**AJ06 - Replacing Connecting Link on Rear PDCC Anti-Roll Bar (Stop Sale/Recall Campaign)**

**Panamera (971)**

**Connecting links on rear PDCC anti-roll bar**

*Installation position of rear connecting link***1** – Connecting link (**replace**)**Parts required**

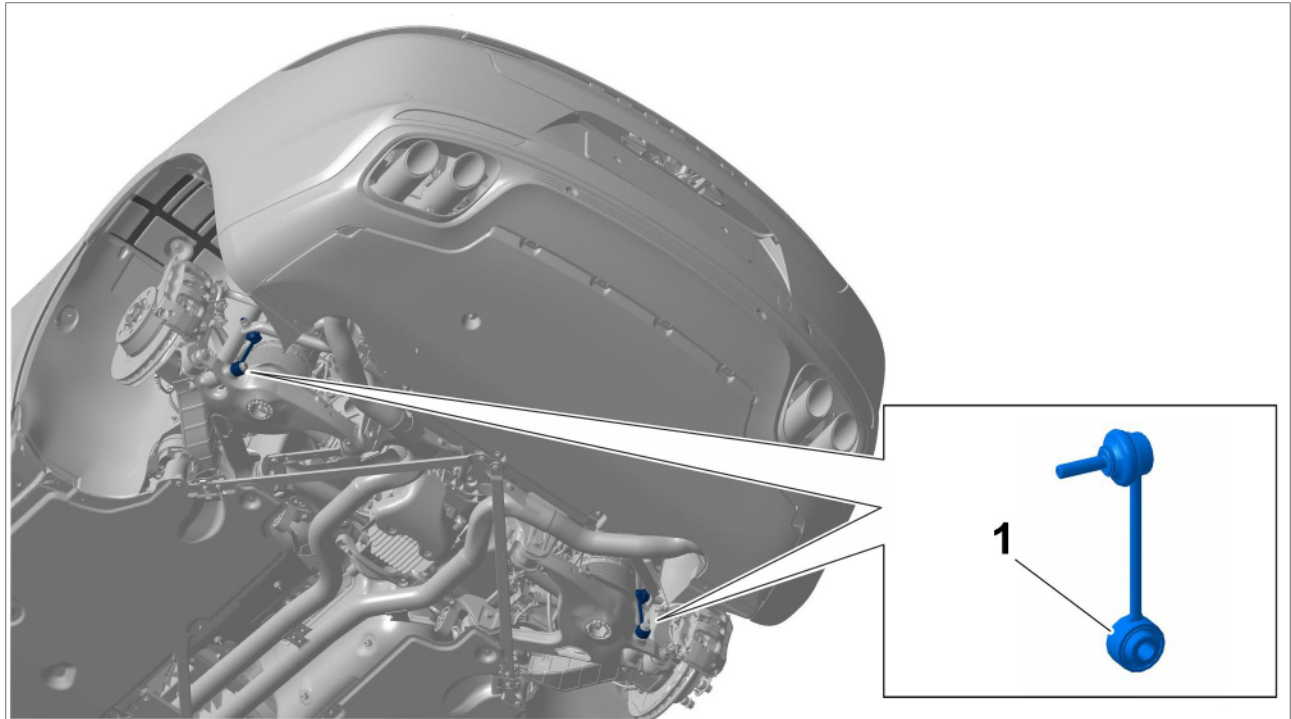
**The durability of the installed connecting links on the rear PDCC anti-roll bar cannot be guaranteed over the service life of the vehicle due to a manufacturing defect.**

This can result in noises and a yellow warning message may be activated. The function of the anti-roll bar may subsequently be impaired, thereby increasing the vehicle's understeer and roll behaviour. If a connecting link is defective, the possibility of damage to adjacent chassis components from the PDCC anti-roll bar cannot be ruled out.

Replace connecting links on the rear PDCC anti-roll bar.
